**JOINT REGIONAL PLANNING PANEL  
(Northern Region)**

**SUPPLEMENTARY REPORT**

**FILE NO: DA11/0257**

Supplementary Report - Development Application DA11/0257 for removal of the existing Police Station and construction of a new two (2) storey Police Station (JRPP) at Lot 701 DP 1002309; Pearl Street KINGSCLIFF

Figure 1 – Extract from Gardner Wetherill & Associates - Basement Level Plan - Drawing Number DA1110

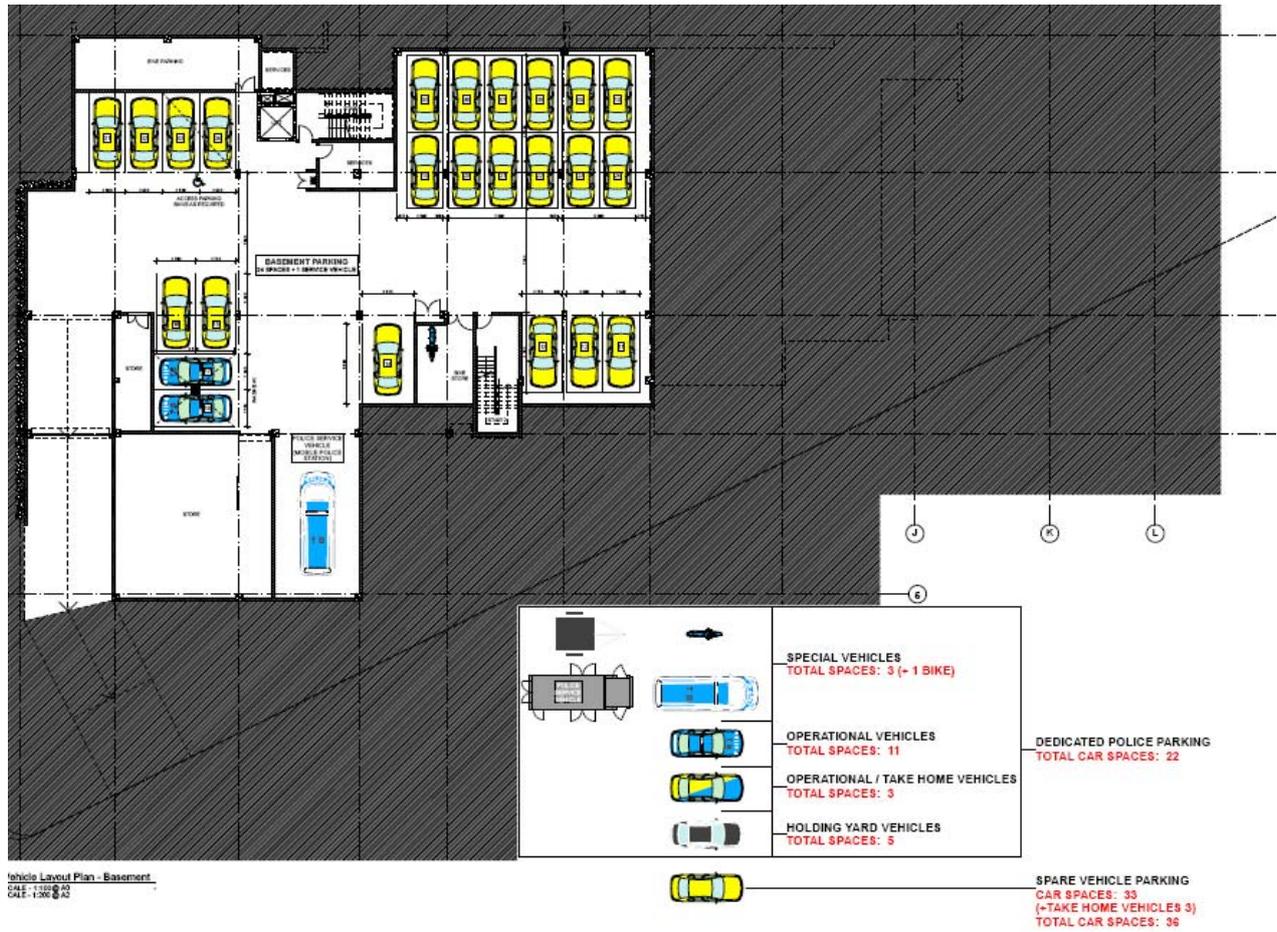
The amended basement plan includes an additional 6 car parking spaces in tandem arrangement. The plan identifies which spaces would be reserved for operational vehicles in blue and 'spare' in yellow.

- 21 'spare' spaces in the basement (assuming only one car in the disabled access parking space and excluding the operational vehicles in the car wash bay)
- 10 'spare' spaces and 3 'operational / take home vehicles' on the ground level.

Similarly, Council officers have only counted 1 space in the disabled space in the basement, assuming that it is being used as intended.

- 14 The car parking indicated as 'spare' in the basement on drawing number DA1110,

Revision A, dated 29.09.11 must be available to staff for parking at all times. The three car parking spaces marked as 'operational / take home vehicles' on drawing number DA1210 Revision A dated 29.09.11 must be available to staff at all times. The proponent must submit a written statement stating that operation of the site will ensure compliance with this condition. Such statement must be provided prior to commencement of building works.

**Figure 2 - Extract from Gardner Wetherill & Associates - Ground Floor Plan - Drawing Number 1210**

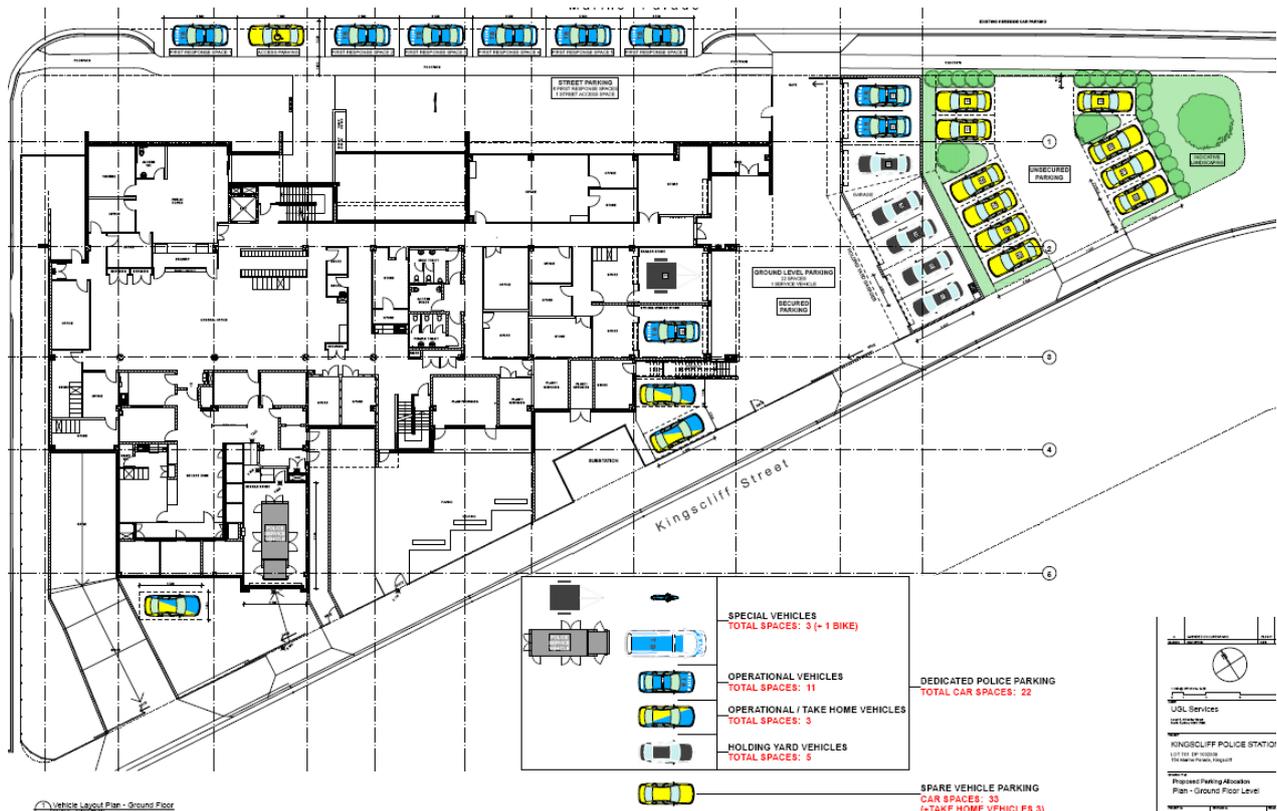
The ground level plan has been modified to include an additional 10 spaces in the landscaped open space on the southern portion of the site. It also clarifies the likely use of car parking spaces at the ground level.

- 13 The ten car parking spaces provided on the site, marked 'unsecured parking' on drawing number DA1210 Revision A dated 29.09.11 must be available at all times for customers and no prohibitive parking signage is permitted. The applicant must provide signage at this location, indicating that car parking is available for customers. Pedestrian access to Marine Parade is to be maintained from the unsecured parking area. The proponent must submit a written statement stating that operation of the site will ensure compliance with this condition. Such statement must be provided prior to commencement of building works.
